RE: Roberts' Improvements to Nenana Ave.

Re: Roberts Property – Nenana Avenue Sight Distance Analysis – Cannon Beach, Oregon
Technical Letter #1 – Supplemental Sight Distance Analysis

This transportation analysis supplements the September 12, 2020 Roberts Property – Nenana Avenue Sight Distance Analysis (Sight Distance Analysis) prepared by Clemow & Associates and addresses the September 22, 2020 City of Cannon Beach Nenana Avenue Plan Review #3 Memorandum prepared by Windsor Engineers.

DRAINAGE SCHEMATIC
NENANA AVE DISCHARGE PIPES

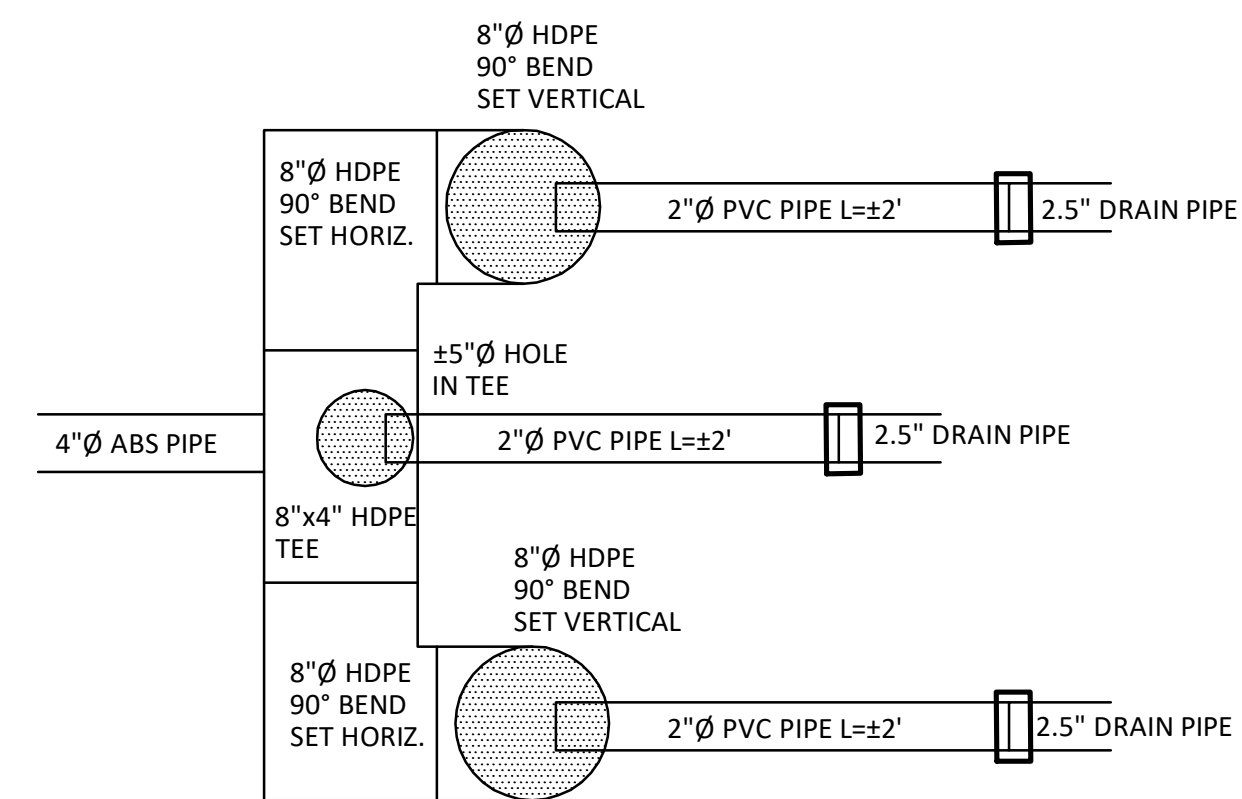
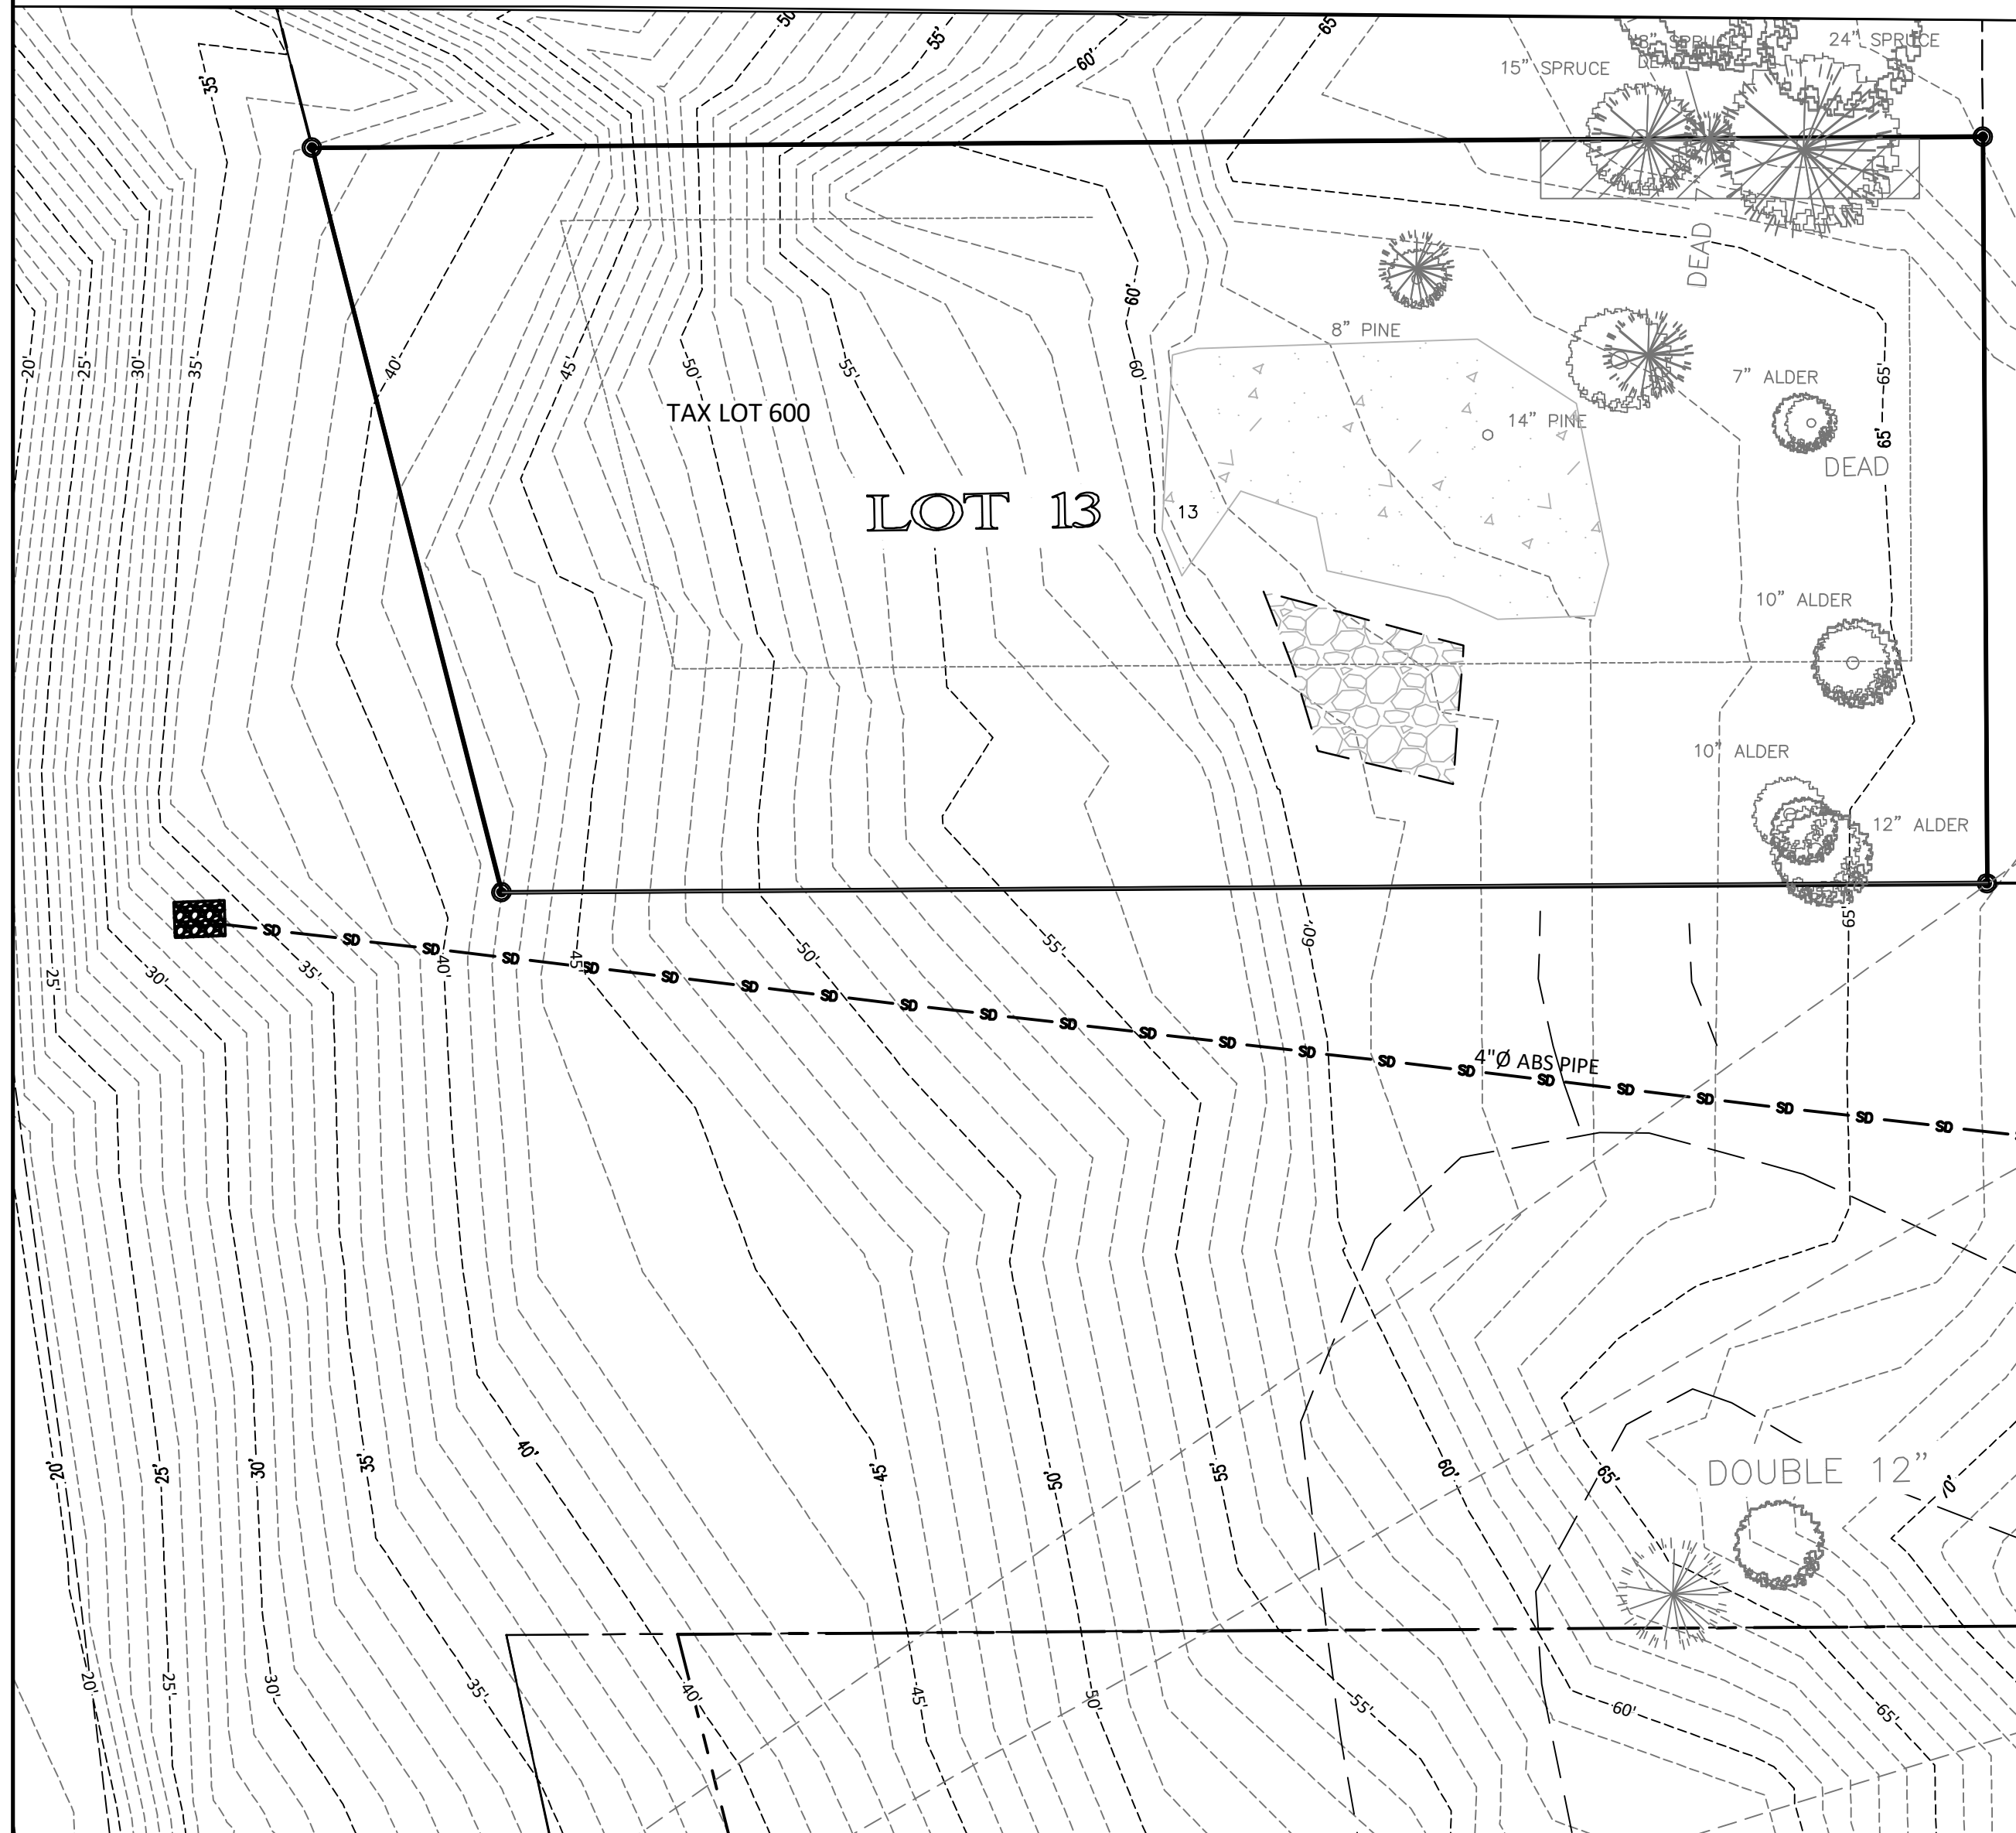
Windsor requested that the Roberts establish that the City will be able to get to its horizontal drain pipes and their terminus below that are below the end of the Nenana Ave right of way:

The proposal will provide the city access to its drains at the beach providing both convenient street access to get to them and the Roberts are willing to allow city employees to access the drains from their property stairs to the beach. Machinery, if needed, could be lifted over Nenana to the beach below. The proposal improves the city’s access to its drains.
